EDMS NO. <b>1973028</b>	REV. <b>0.1</b>	VALIDITY <b>DRAFT</b>
----------------------------	--------------------	--------------------------

REFERENCE  
**LHC-TC-EC-0013**

## ENGINEERING CHANGE REQUEST

# Installation in IR7 of Dispersion Suppressor Collimators (TCLD)

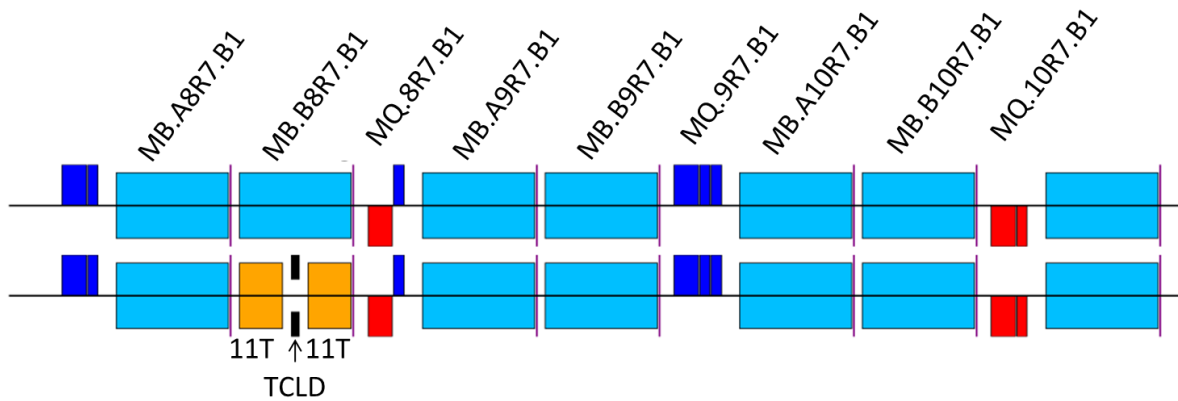
Simulations and present knowledge of the quench limits of the standard dipoles as well as the 11 T magnets have shown that the preferred placement of the TCLD is in cell 8 (on the right side of IR7 for B1 and left side for B2) [8]. The standard dipoles to be replaced by the assembly of two 11T magnets are MB.B8R7 and MB.B8L7. The schematic layouts of the present and post-LS2 IR7 dispersion suppressor on the left side of IR7 are shown in Figure 1.

Figure 2 - Positions of new TCLD collimators in IR7. Figure taken from Ref. [12].

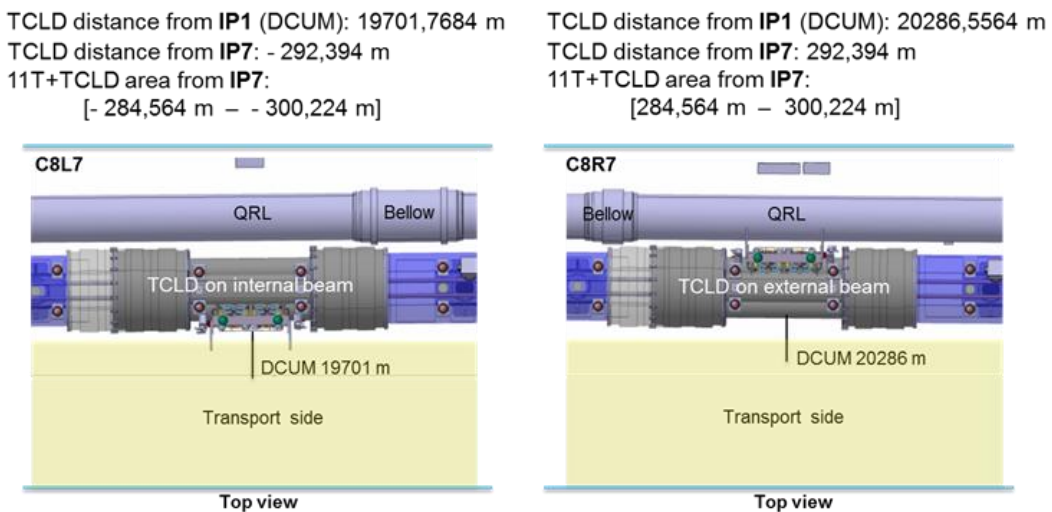
The integration and positions (DCUM) of the two TCLDs are shown in the drawings in Figure 2. More details on the integration are presented in [12], although this document (version from March 2018) needs to be updated with the very latest design additions.

Figure 3 — Drawing of one of the TCLD jaws, including RF fingers, cooling pipes and BPMs. Courtesy of L. Gentini – SmarTeam numbers ST0676575 (L7) and ST0918055 (R7).

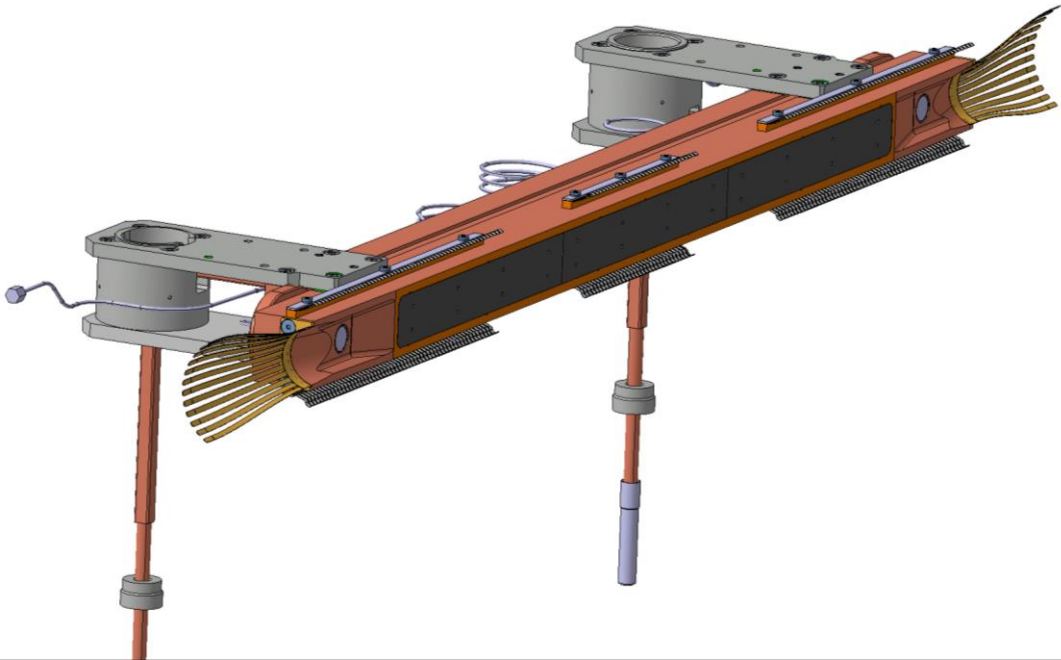
The TCLD consists, as most other LHC collimators, of two parallel jaws collimating the beam in the horizontal plane, with the beam passing in between them. The active material of the jaws is the tungsten alloy Inermet 180. The design of the TCLD collimator, shown in more detail in Figure 3 and Figure 4, is derived from the design of the present LHC collimators, but with some differences. Because of the very tight space requirements, the design is challenging and the active length of the material had to be reduced to only 60 cm, in order to make it fit. This means that also a non-standard support design is used. The shorter length has only a minor adverse effect on the downstream energy deposition [10, 11]. Furthermore, the bellows at the two longitudinal extremities are integrated in the tank transitions in order to gain longitudinal space. Special tooling for transport, handling and for the retraction of the collimator bellows during the installation has been designed. In order to gain as much space around the TCLD vacuum tank as possible, a new thinner set of heating jackets (aerogel) has also been produced. A 3D drawing of the tank and support is shown in Figure 5.

Figure 7 – The assembly to be installed between the two 11T dipoles, consisting of TCLD collimator, support, beam pipe for the other beam, and cryo-bypass. Courtesy of L. Gentini – SmarTeam numbers ST0676575 (L7) and ST0918055 (R7).

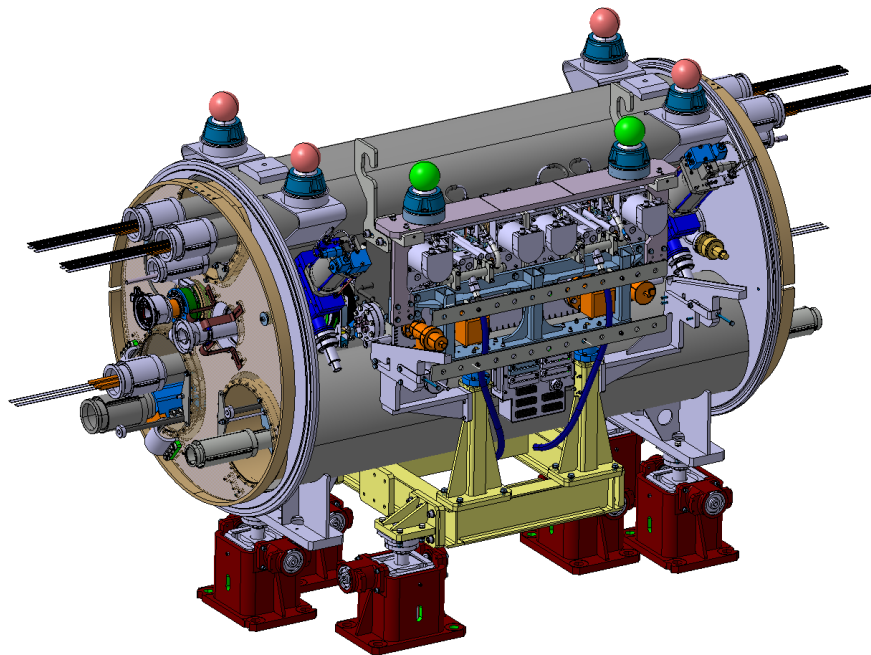
The characteristics of the TCLD are summarized in Table 1. The layout names for the new collimators and the names of the embedded BPMs are listed in Table 2. The TCLD will be integrated in a specially designed assembly, containing a beam pipe for the other beam, as well as a cryo-bypass, which is needed since the TCLD is a warm element placed between two cold ones. This assembly is shown in Figure 7 and the full installation including the two 11T dipoles is shown in Figure 8. For the TCLD of R7 only, it is needed to include a standard LHC bridge (removable) and a platform above the QRL in order to provide an easy access to the rear side of the TCLD to complete the installation and for future maintenance [12].
